Re: BSP Application #302, SP Application #302, Flood Damage Prevention Application #383, Land Filling & Regrading Application #436, Proposed Amendment of Zoning Map #1-2018 & Proposed Amendments of Zoning Regulations #5-2018

Corbin Development

Re: Comments Received from Fred Doneit, Planning & Zoning Staff

Re: Post Road/Corbin Drive Sewer System

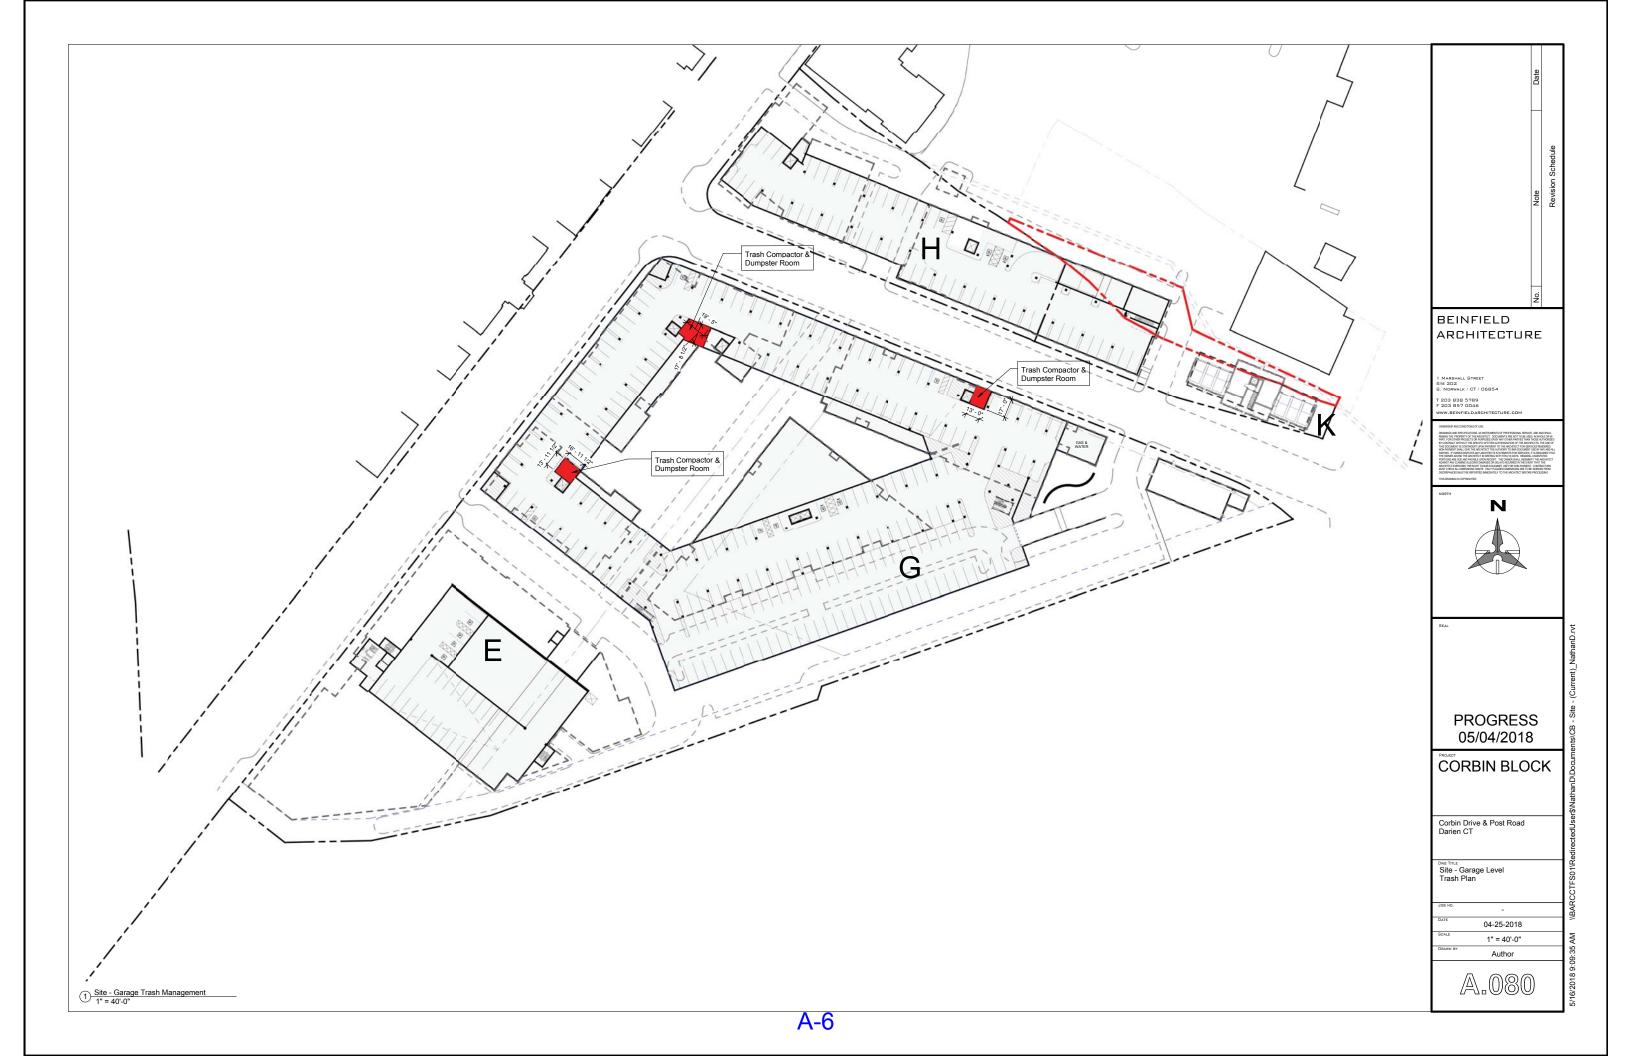
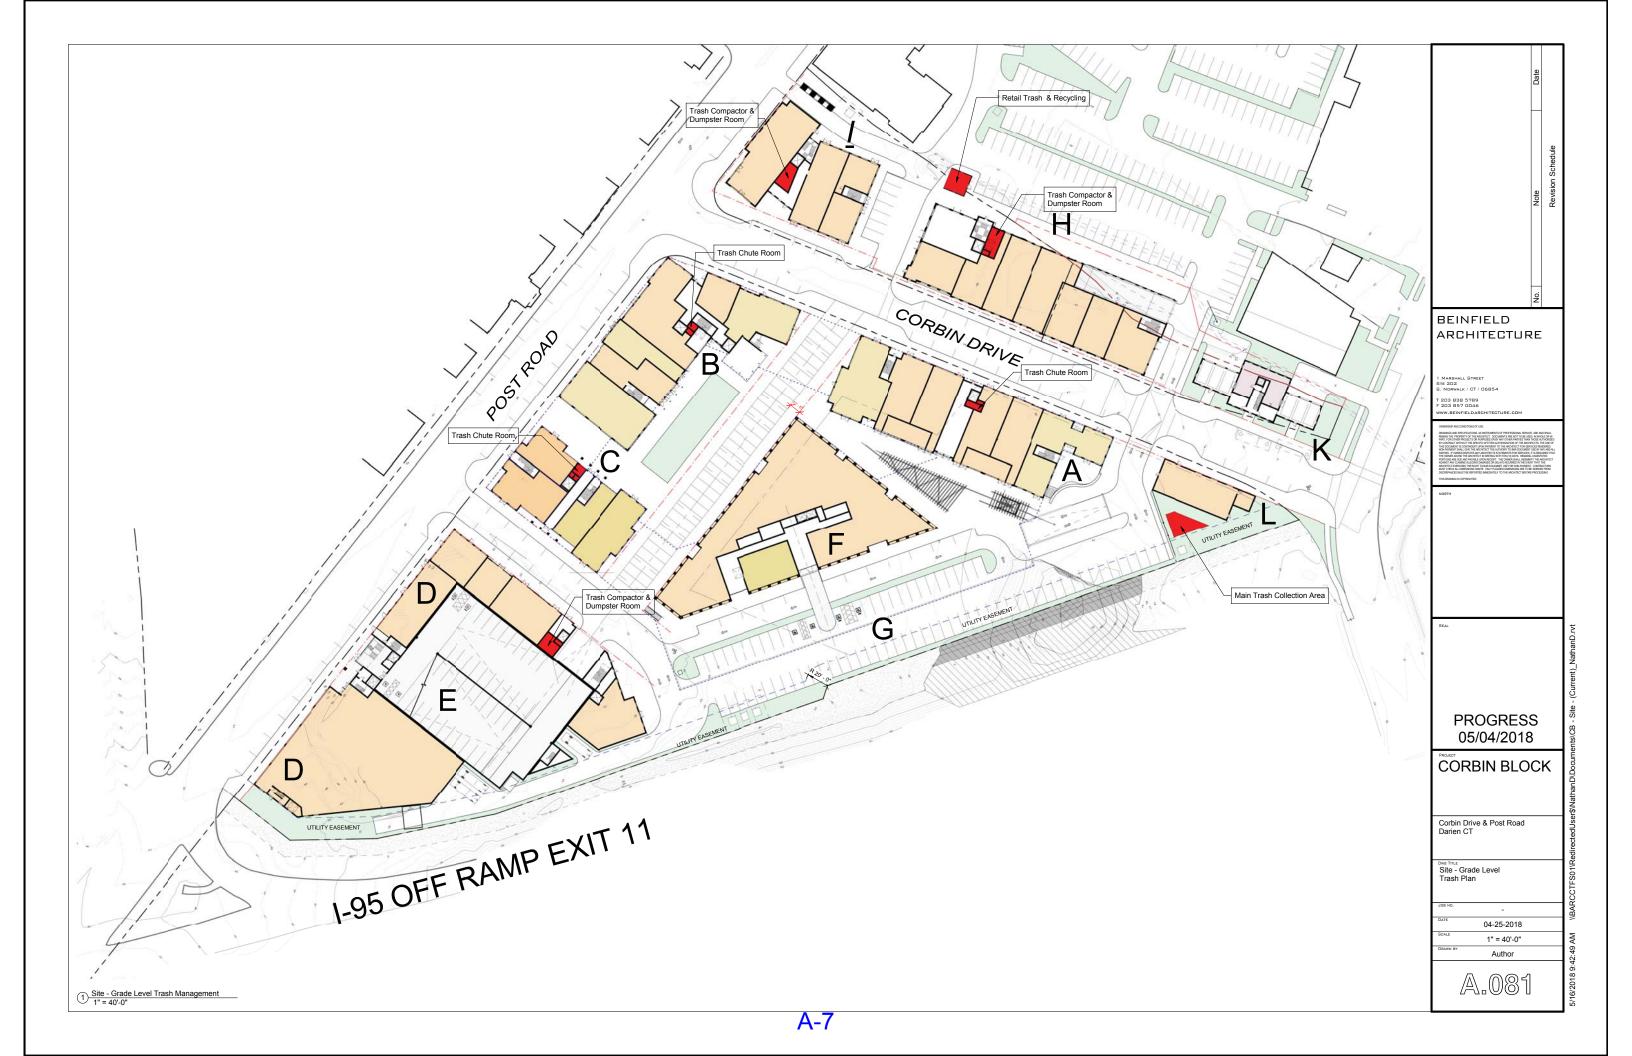
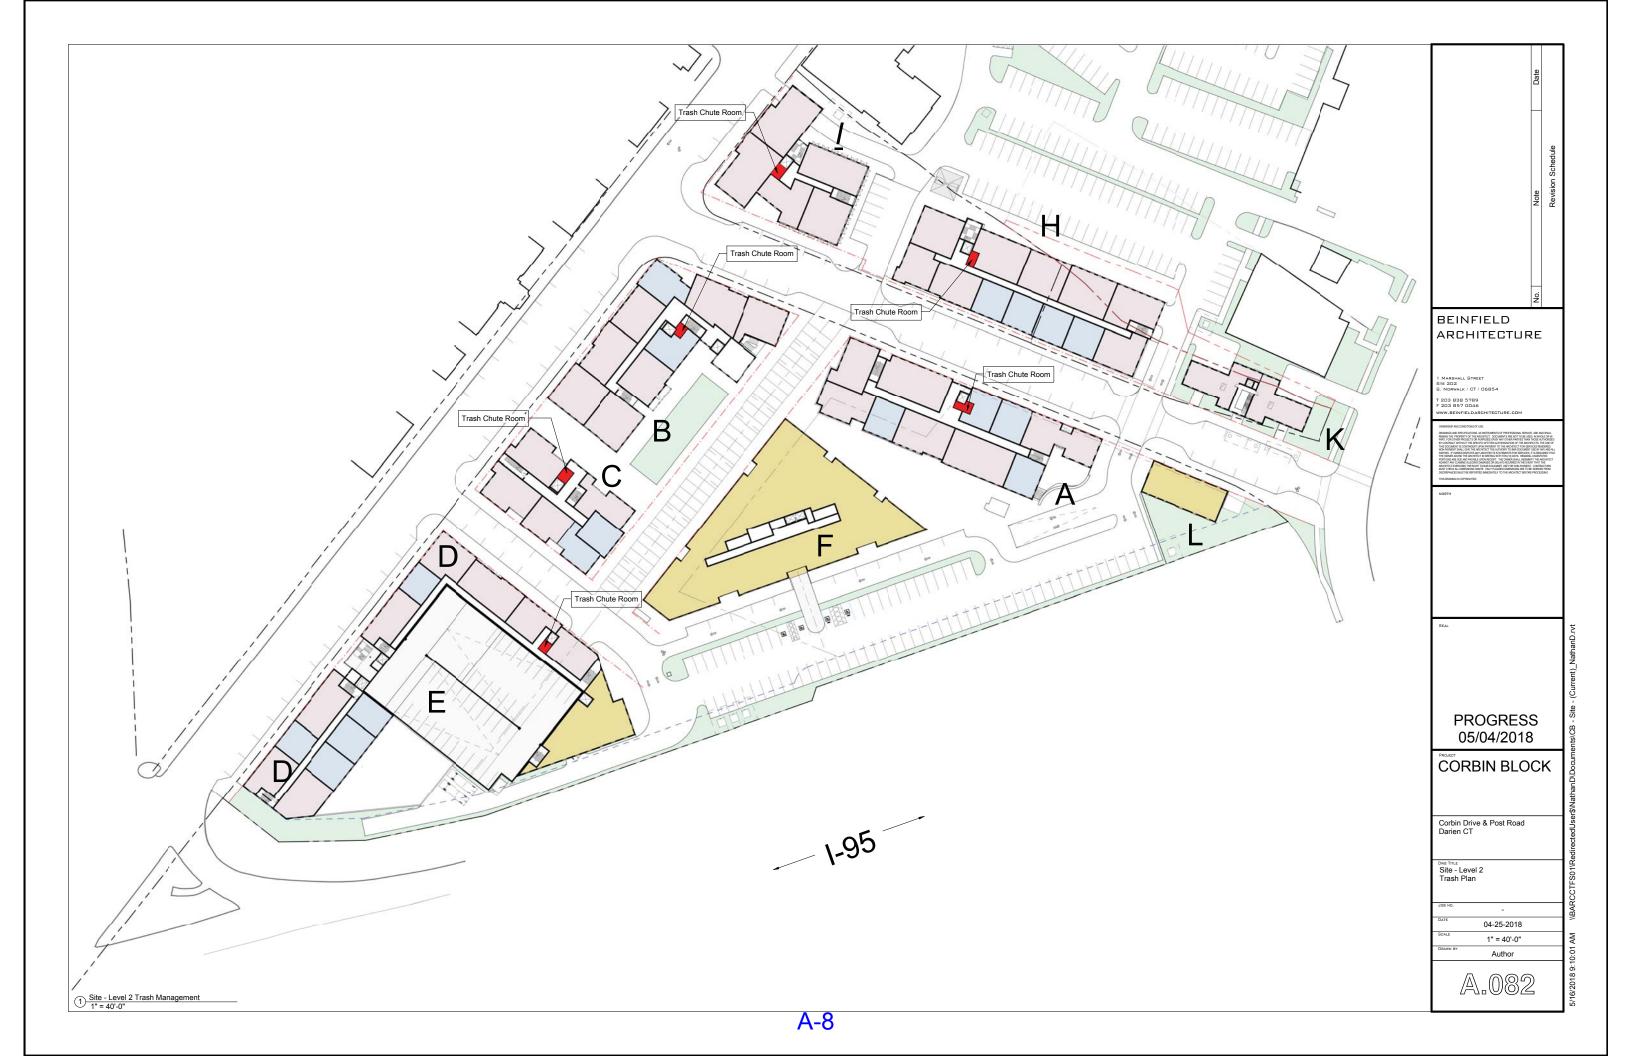
All of the retail spaces will be serviced at grade level. Designated areas on the property will house in corralled spaces 2-6 yard containers. One of the containers will be specifically for single stream recycling and one specifically for trash. These retail containers will be serviced by a front load truck. The frequency levels will be determined by store or restaurant activity, suggested level to start would be one day a week. As the retail spaces become occupied the level of service would multiply due to increases in commodity generation (See site map for corral locations).

Each residential structure has a trash room area to collect recycling and to utilize the trash chute. This trash chute will be installed while under construction. It comes with safety doors and a fire sprinkler system. In the trash room a 95 gallon roll-out cart will collect the recycled materials. All of the trash will be placed into the chute which feeds the compactor unit at the garage level area. Attached to the compaction unit is a 2 yard container this 2 yard container receives the trash compacted by the unit. In the garage level trash rooms a 2 yard switch box will be staged to receive overflow for move-ins etc. Along with the switch box, another 4 yard container will be staged in the garage level area to receive all recycling materials generated from the upper floor trash rooms. The 95 gallon roll-out carts assigned to the trash rooms on the upper floor will be used as a delivery container to bring the recycling to the 4 yard can at the garage level. Lastly, when the scheduled day arrives to service the garage level containers a porter will via John Deer Gator tow the full cans to grade level for pick-up. Again suggested level of service would begin at one day a week until leasing increases. These containers will also be serviced by a front load truck. (See site map for trash room locations)

Response 4: Figure 3 is attached for review

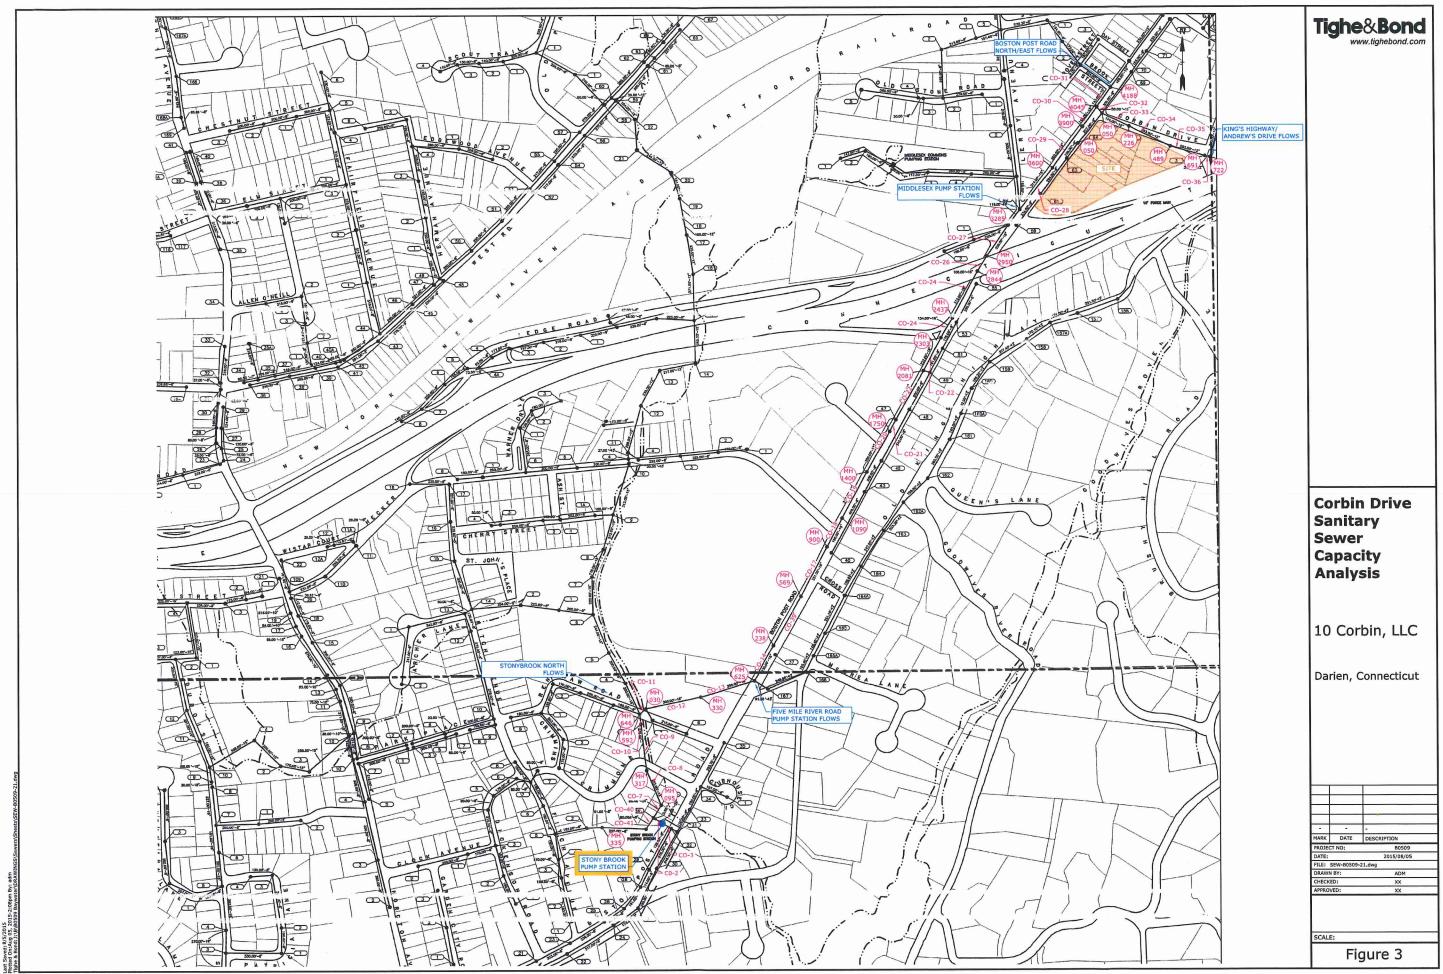
<u>Comment 4</u>: Page 5, under Sewer Capacity Evaluation, Reference to Figure 3 and Appendix B of report references segment ID's. Figure 3 not found. Appendix B highlights surcharged lines however Figure 3 was not found and therefore segments could not be identified nor located.
